# UNITED STATES PATENT AND TRADEMARK OFFICE

10/576,421

<b>Office Action Summary</b>	<b>Application No.</b> 10/576,421	<b>Applicant(s)</b> HAYASHI ET AL.	
	<b>Examiner</b> CLAIRE L. RADEMAKER	<b>Art Unit</b> 1795

## **DETAILED ACTION**

The following illustration (modification of Mizutani Figure 1) is provided for clarification:

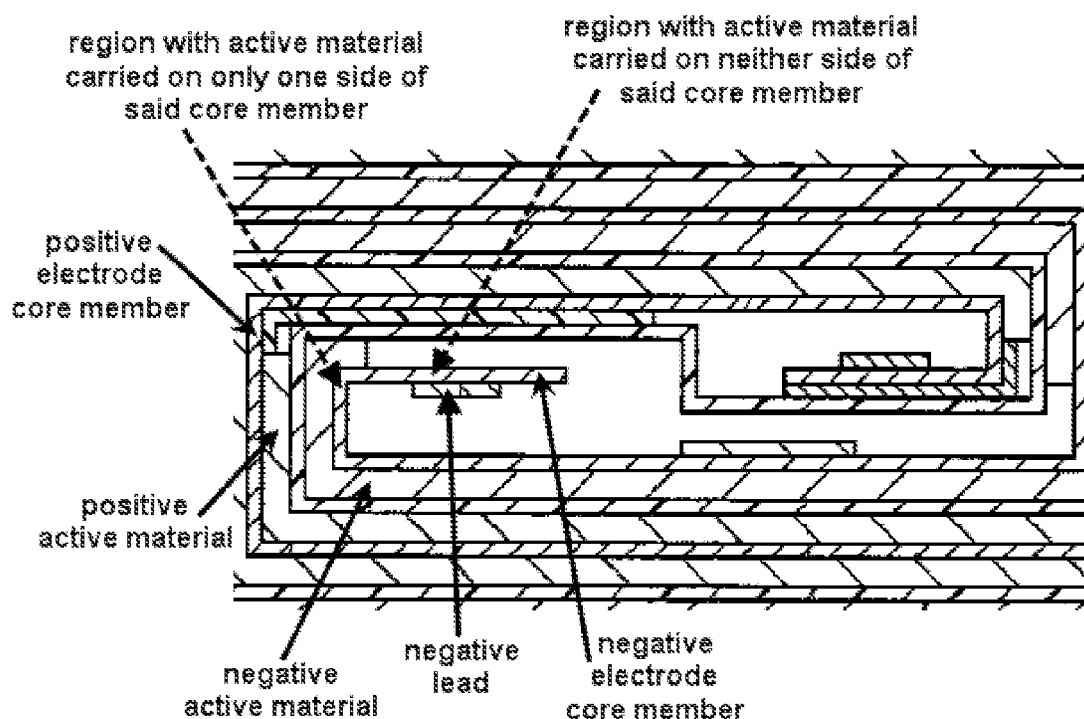
With regard to claims 1 and 3-4, Mizutani et al. teaches a lithium ion secondary battery (paragraphs [0037]-[0038]; Figure 1) including an electrode group that comprises:

a positive electrode comprising a positive electrode core member (15, paragraph [0044]; Figure 1) and a positive electrode active material layer (2, paragraphs [0038] & [0044]; Figure 1) carried on said positive electrode core member (paragraph [0044]; Figure 1),

a negative electrode comprising a negative electrode core member (16, paragraph [0047]; Figure 1) and a negative electrode active material layer (3, paragraph [0038]; Figure 1) carried on said negative electrode core member (paragraphs [0038] & [0047]; Figure 1),

a porous film (1, paragraphs [0038] & [0050]; Figure 1) disposed between said positive electrode and said negative electrode (paragraph [0038]; Figure 1), wherein said positive electrode and said negative electrode are wound (paragraph [0038]; Figure 1), and wherein said negative electrode has, on the initial winding side, a region where said negative electrode active material layer is carried on neither side of said core member (paragraph [0056]; Figure 1) and an adjoining region where said active material layer is carried on only one side of said core member (paragraph [0038]; Figure 1), and

a lead (9, paragraphs [0038] & [0056]; Figure 1) provided in the region of negative electrode where the active material layer is carried on neither side of said core member (9, paragraphs [0038] & [0056]; Figure 1).

Mizutani fails to teach the specified composition of the porous film layer.
